# RHA - NOTES FROM THE FIELD

## CIVIL AND SITE COORDINATION

COURTYARD FRONT ELEVATION

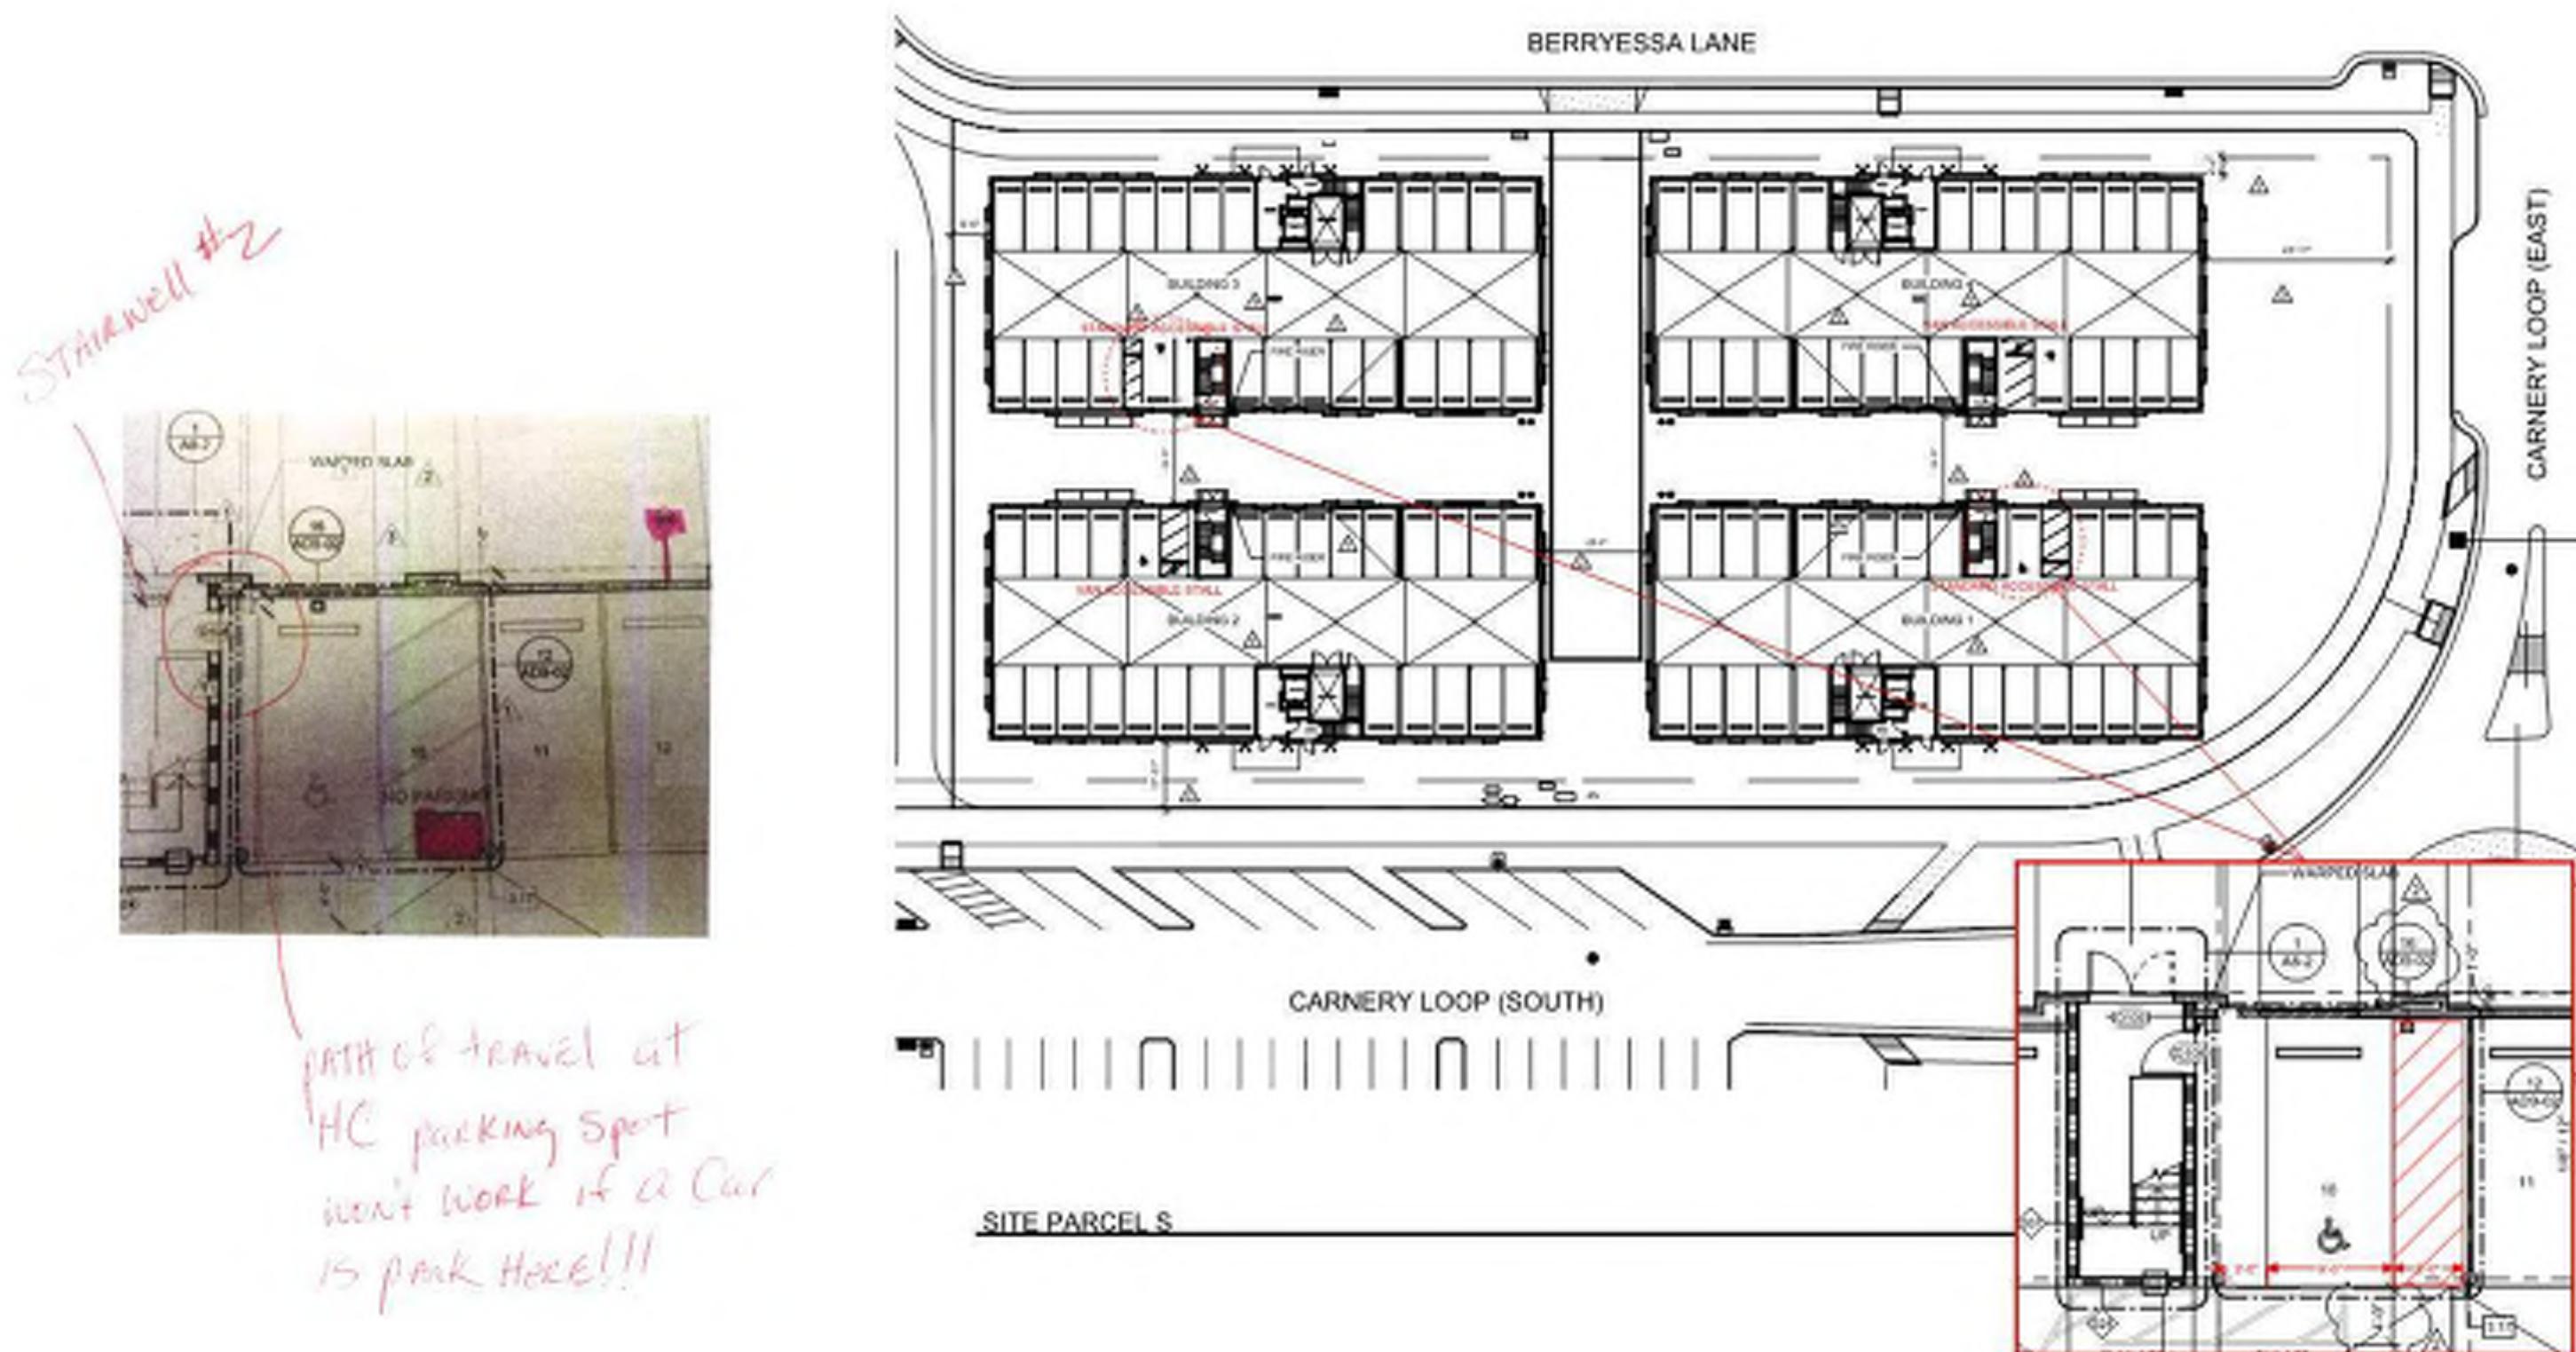
TAKE-AWAY: Coordinate pad heights with the plan

# TRUSS AND HEEL HEIGHT DESIGN

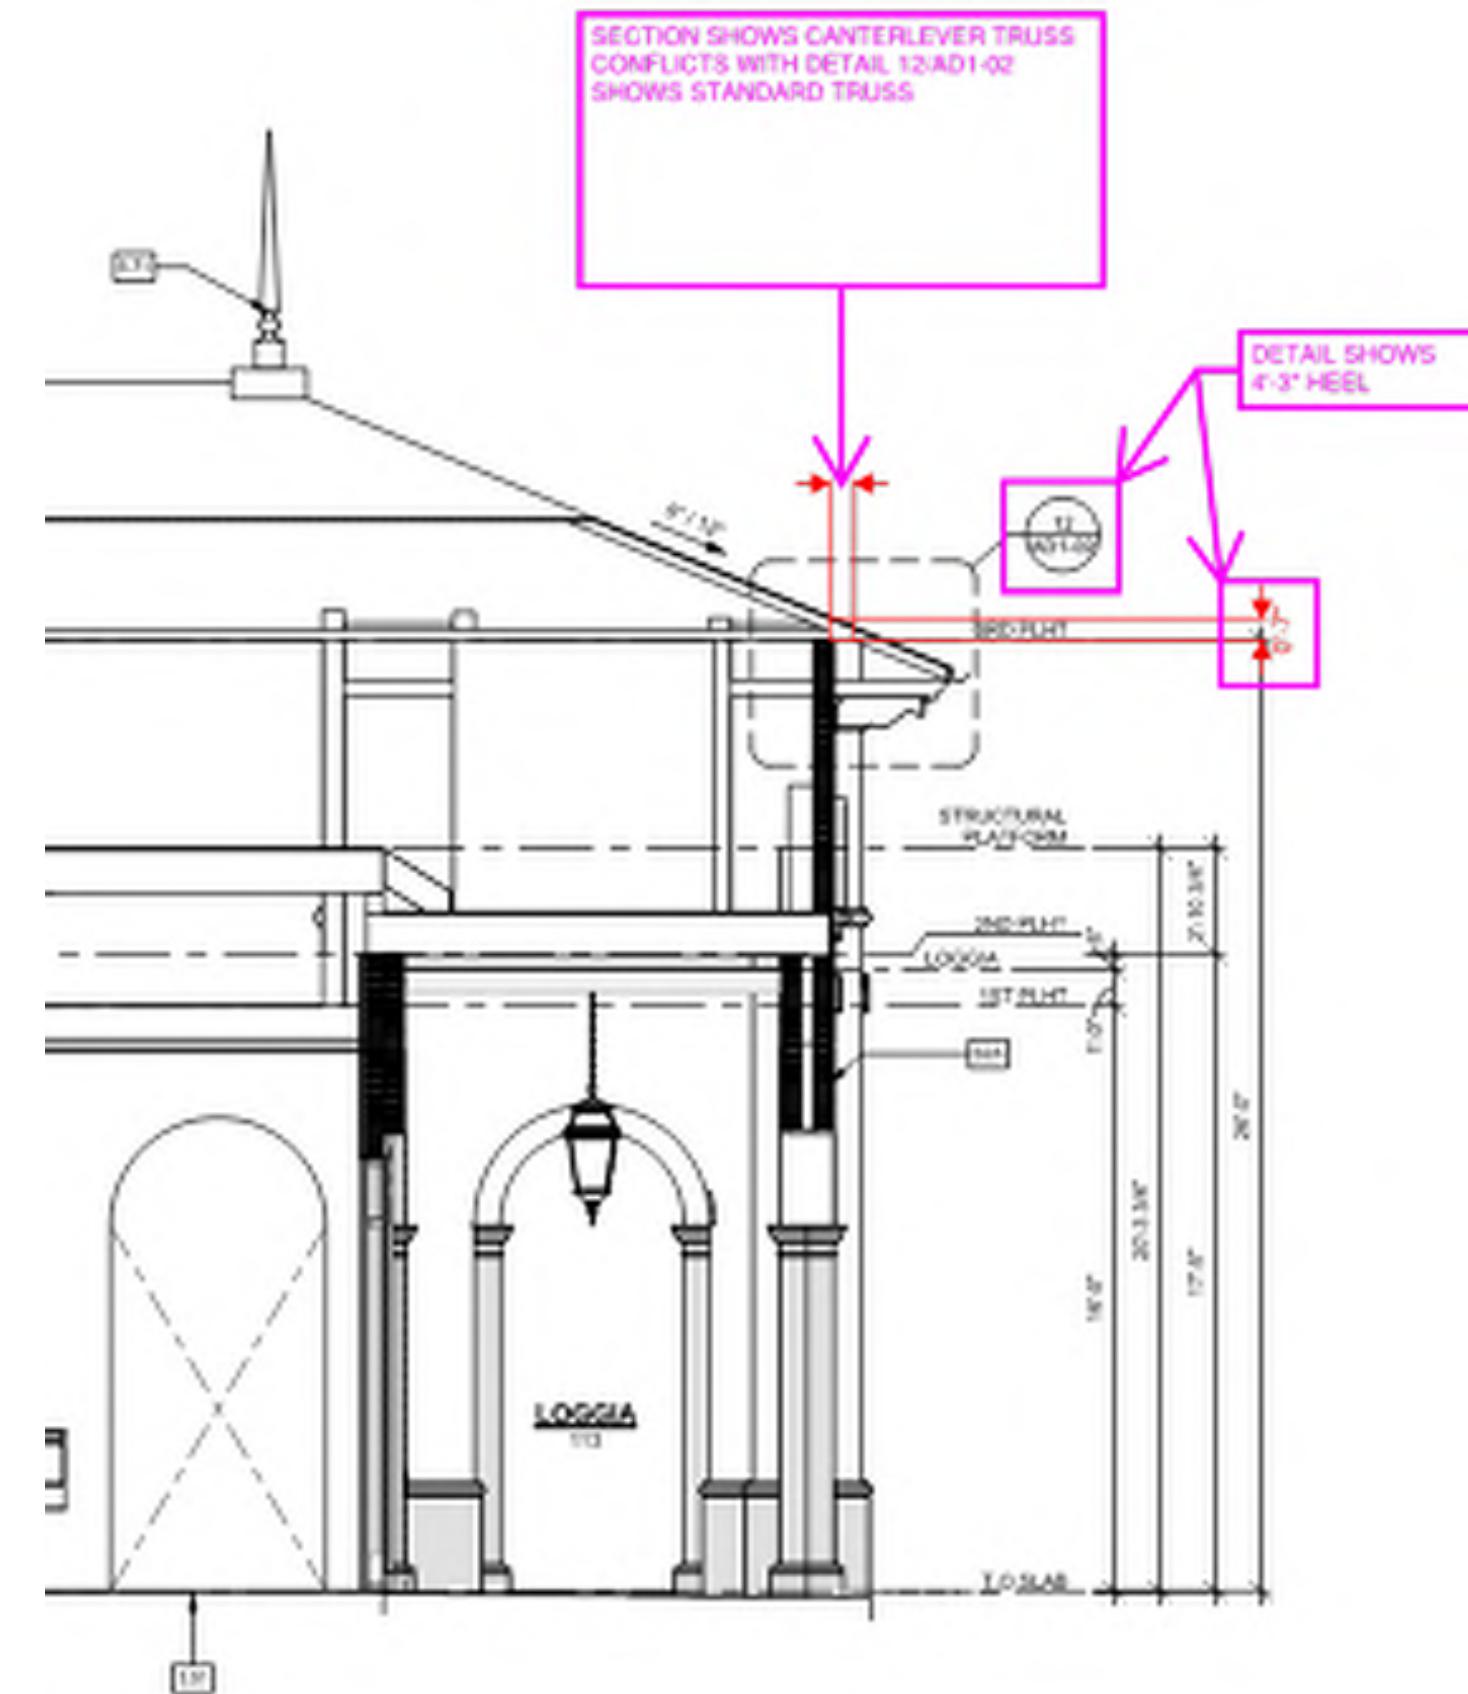
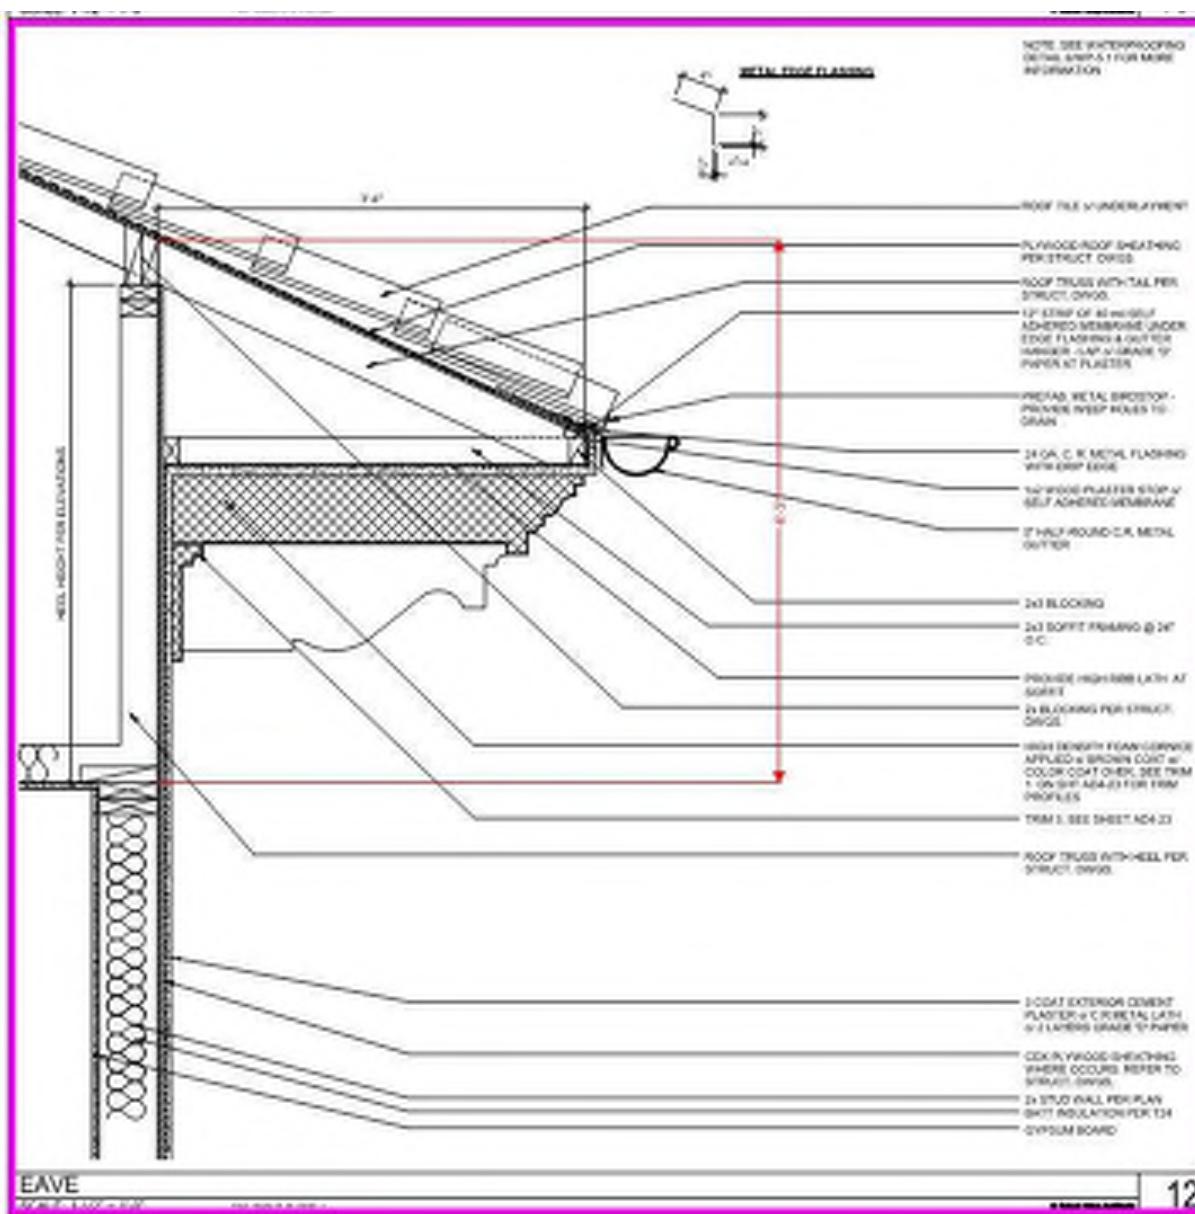
**TAKE-AWAY:** Coordinate model with architectural detailing

## TRUSS AND HEEL HEIGHT DESIGN

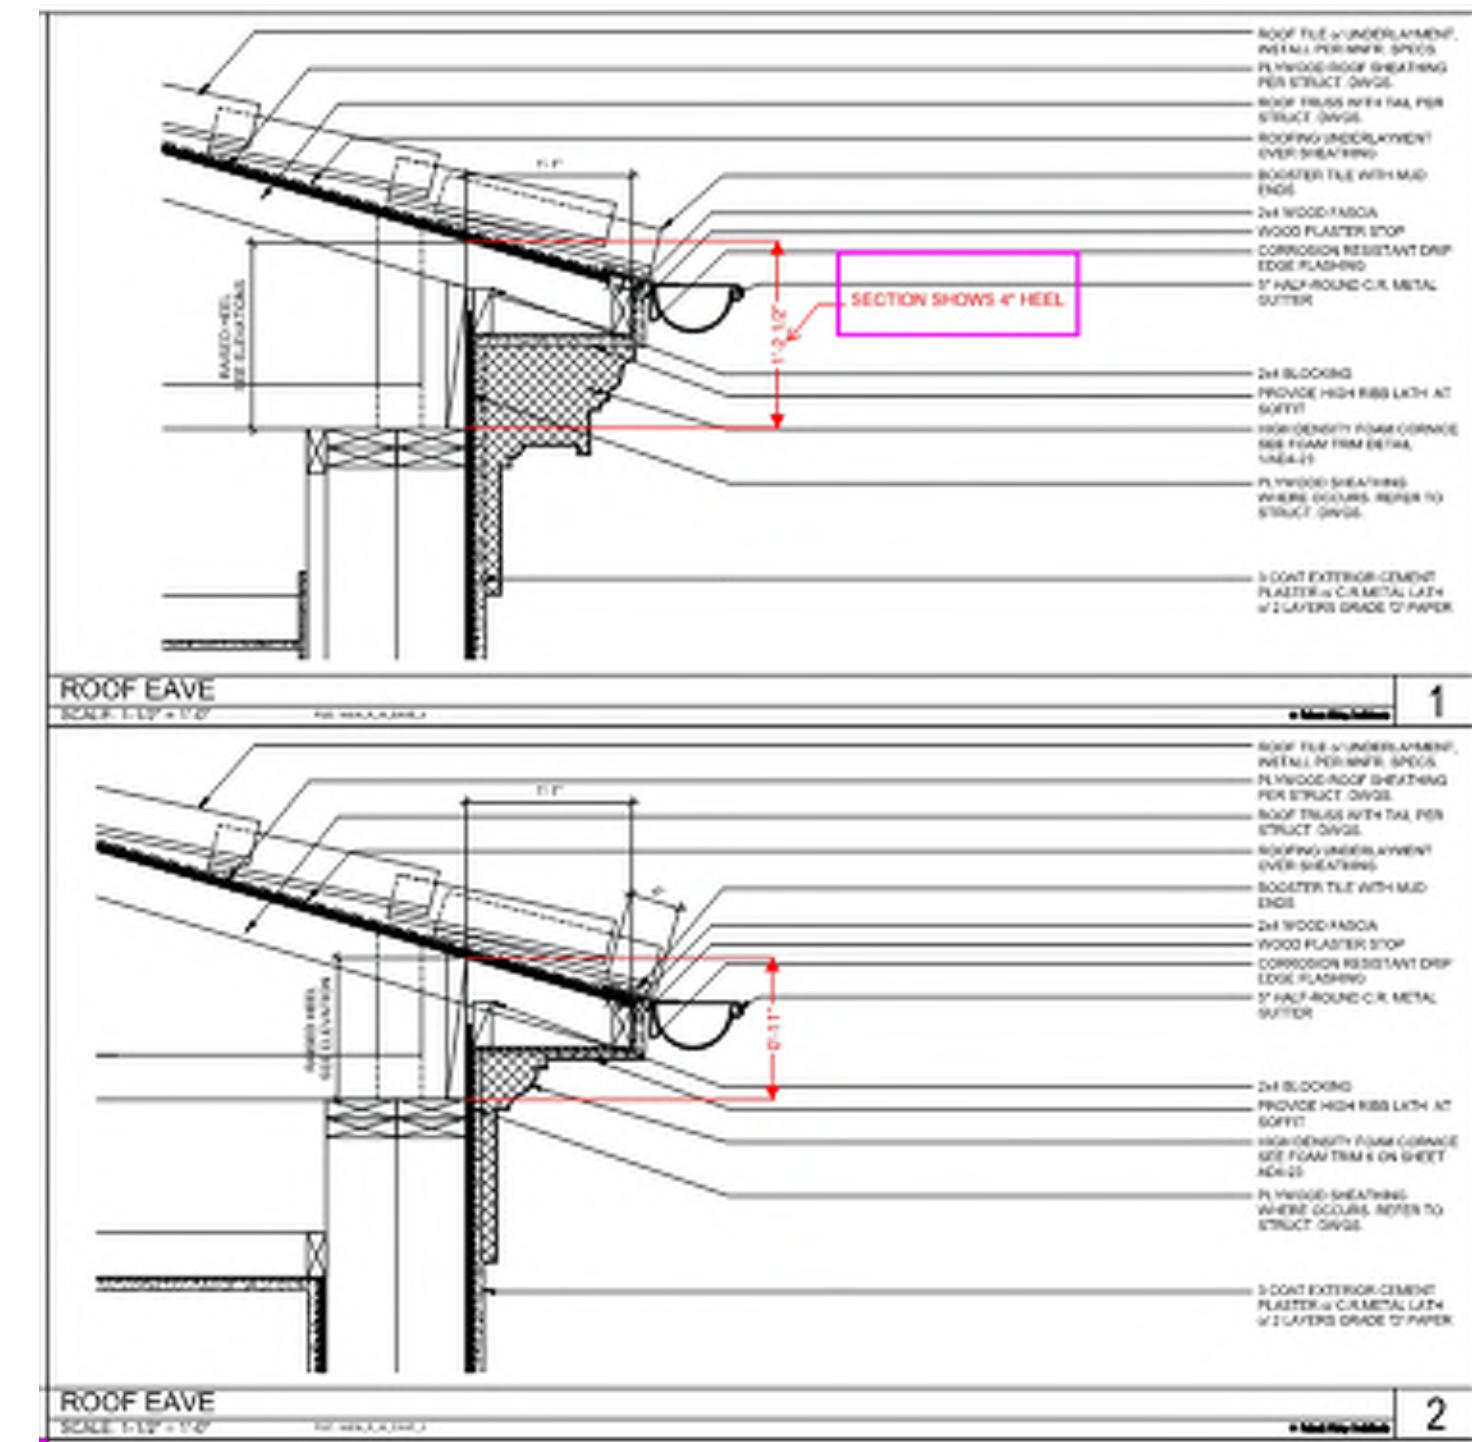
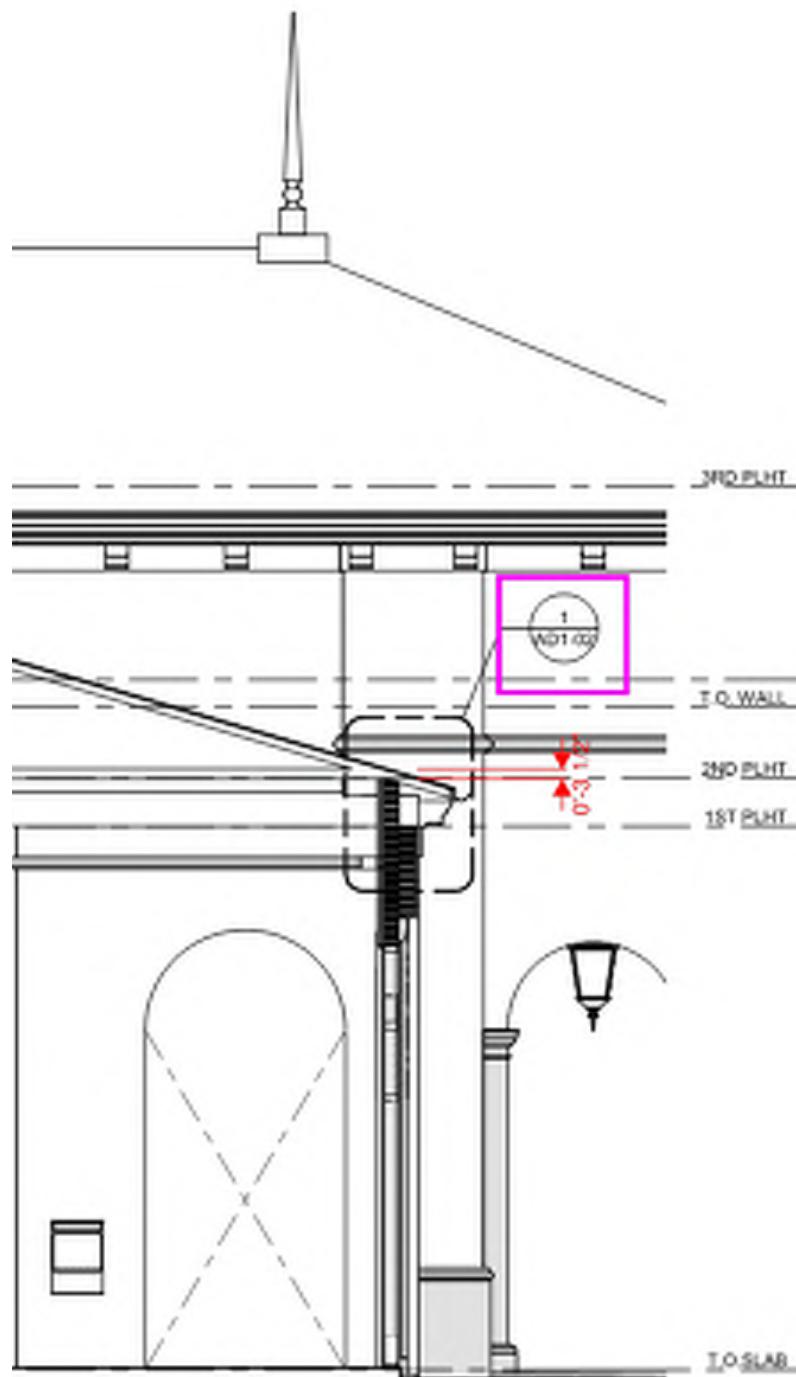
TAKE-AWAY: Coordinate model with architectural detailing
